# Development Application Assessment Report

<b>Panel Reference</b>	PPSSTH-31
<b>DA Number</b>	DA.2020.1022
<b>LGA</b>	Queanbeyan-Palerang Regional Council (QPRC)
<b>Proposed Development</b>	<ul style="list-style-type: none"> <li>» Demolition of an existing substation that serviced the previous Council Administration building at 257 Crawford Street</li> <li>» Decommissioning and removal of existing substation adjacent to the previous Council Administration building</li> <li>» Construction of two new substations</li> <li>» Partial demolition relating to Bicentennial Hall &amp; The Q Foyer / Link</li> <li>» Demolition of existing structures and buildings at 10 and 12 Rutledge Street</li> <li>» Construction of a seven-storey public administration building at 257 Crawford Street (including basement)</li> <li>» Establishment of a new service lane from Crawford Street</li> <li>» Construction of new ground floor linkage Bicentennial Hall / The Q Foyer</li> <li>» Construction of mezzanine level from Bicentennial Hall to the new public administration building</li> <li>» Establishment and landscaping of a Crawford Street Plaza</li> <li>» Establishment and landscaping of The Q Plaza</li> <li>

Figure 2 Site Boundary

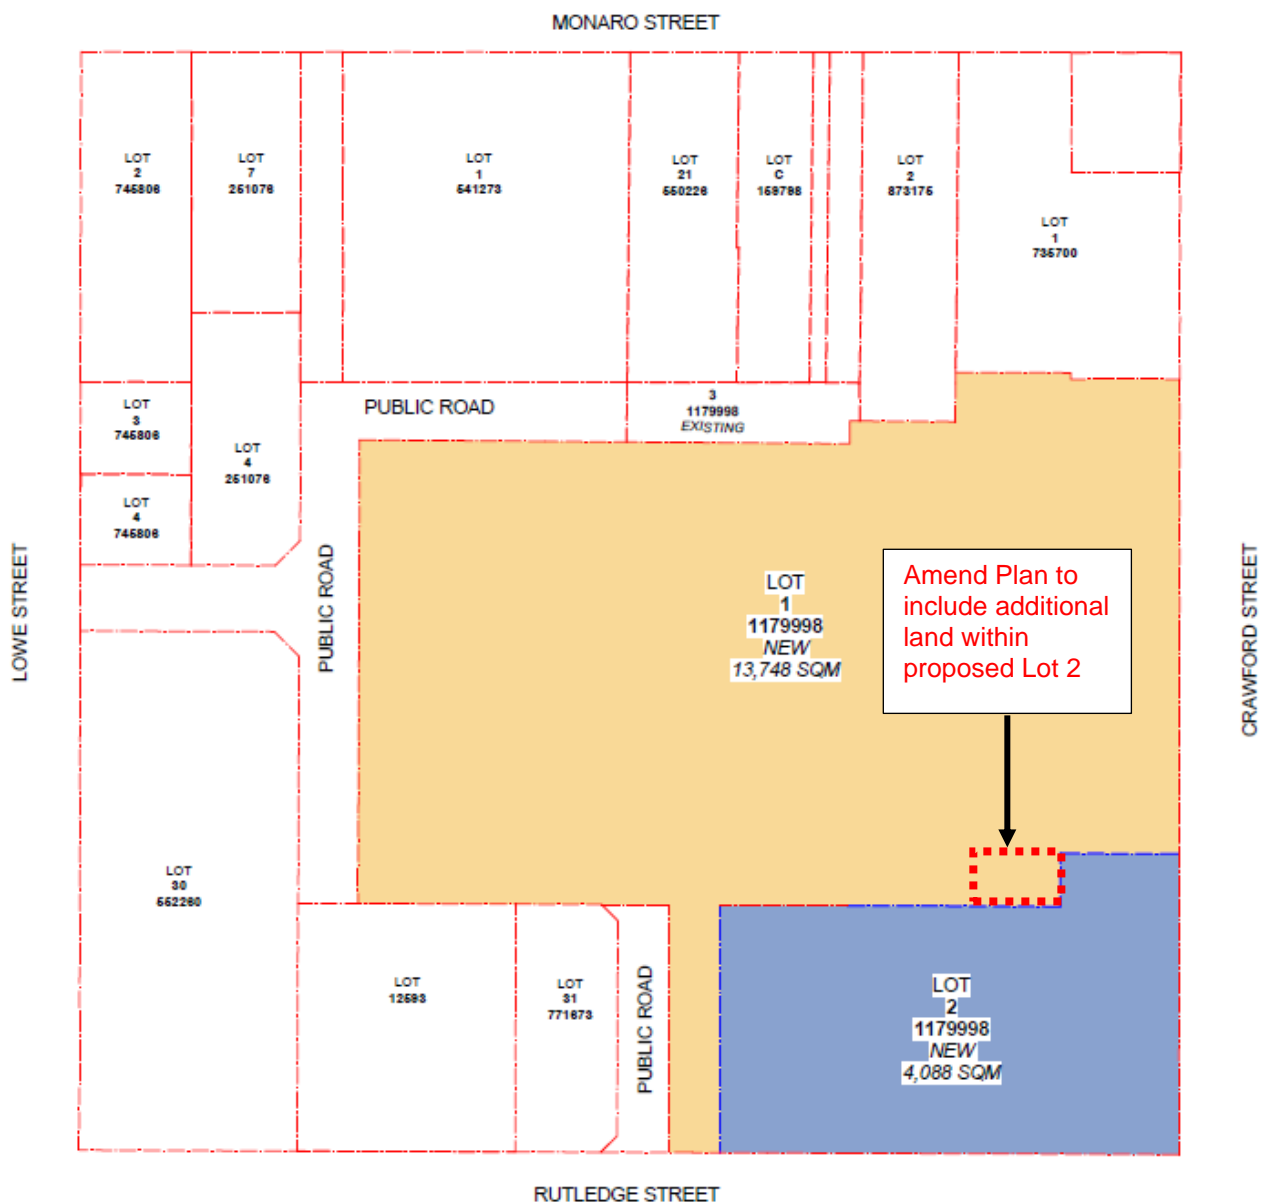
- a. Confirms site boundaries
- b. Assesses the amended Clause 4.6 variation request, including considering the extent to which the site is unique, and includes a clear recommendation.

The boundary of the site is shown in drawing DA-11-01 Date 10.12.19 Revision 8, Cox Architecture. The development will be contained within proposed Lot 1 DP 1179998 as shown on the subdivision plan drawing DA-10-02 Date 10.12.19 Revision 6, Cox Architecture (extract below).

Following consideration of the recommendations from the Heritage Committee and Council's Heritage Advisor, a condition has been added to amend the size of the Fire Station lot to accommodate additional curtilage to the Heritage Item.

**Figure 1 Building Envelope Diagram**

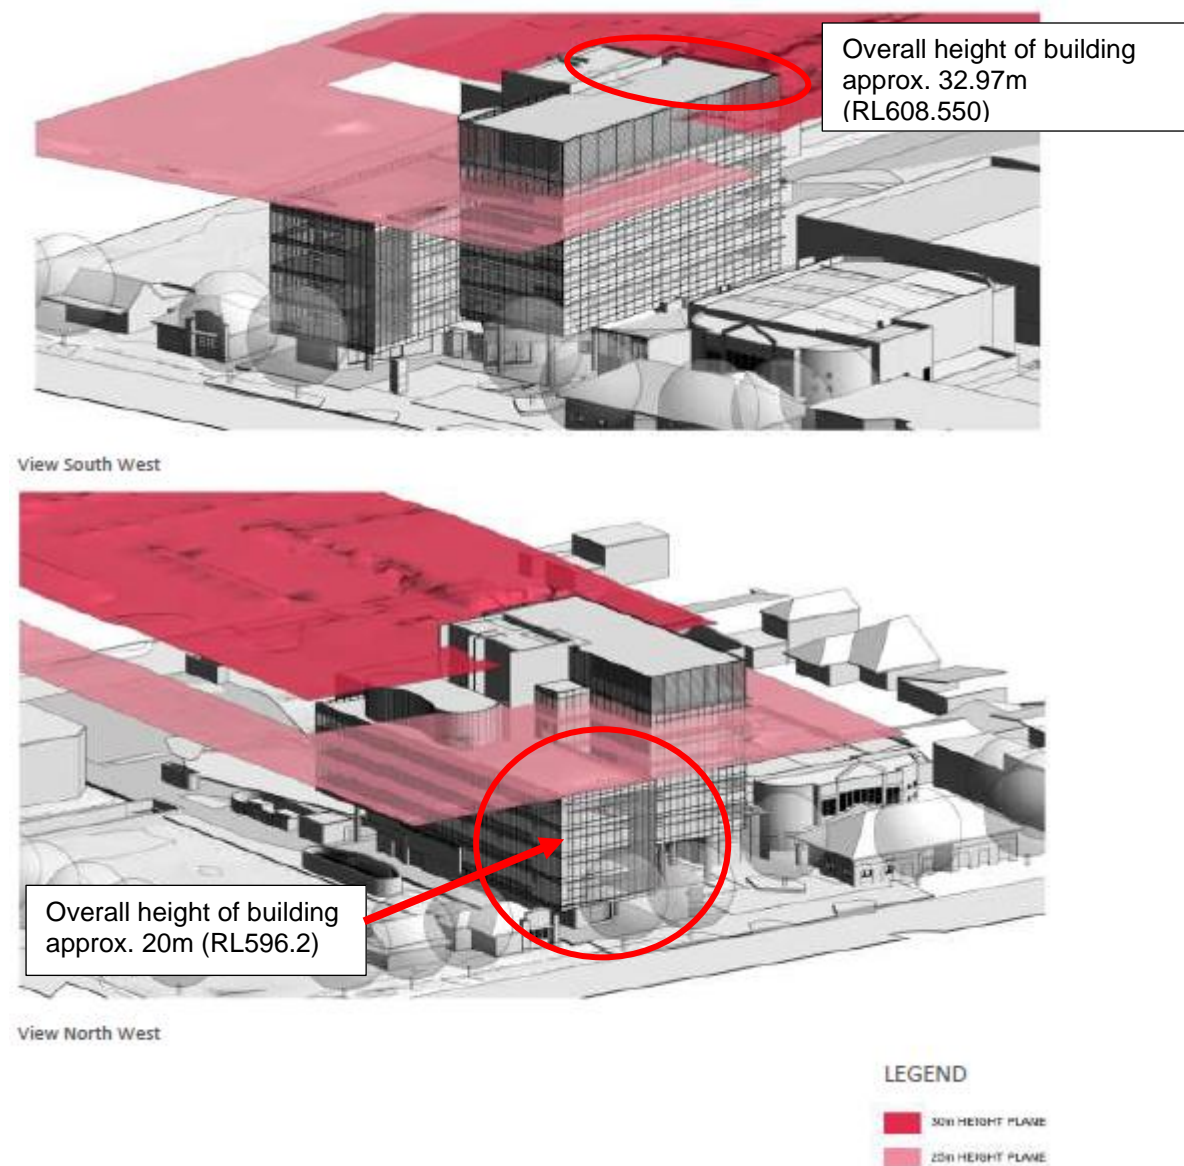
**(b) Assesses the amended Clause 4.6 variation request, including considering the extent to which the site is unique, and includes a clear recommendation.**

The development spans two height of building planes; 25m fronting Crawford Street and 30m through the middle of the block. The variable height plane allows for a stepping back of height such that that part of the building the is closest to the street is lower and may be less imposing. The building envelope diagram, and revised height of building drawings are shown in **Figure 3** below.

- » Over the 25m portion of the site (shown light pink), the proposed building envelope has a maximum height of 32.97m, resulting in a maximum non-compliance of approximately 7.97m or 32%.
- » Over the 30m portion of the site (shown dark pink), the proposed building envelope has a maximum height of 32.97m, resulting in a maximum non-compliance of approximately 2.97m or 10%.

However, the height exceedance is limited to a smaller portion of the building across the two height planes as demonstrated below.

In assessing and recommending approval of the clause 4.6 variation request, Council must be satisfied with the matters set out in clause 4.6(4). The revised clause 4.6 variation now satisfied these requirements.

That the variation to the Height of building clause be acknowledged and the variation under clause 4.6 of the LEP be accepted.
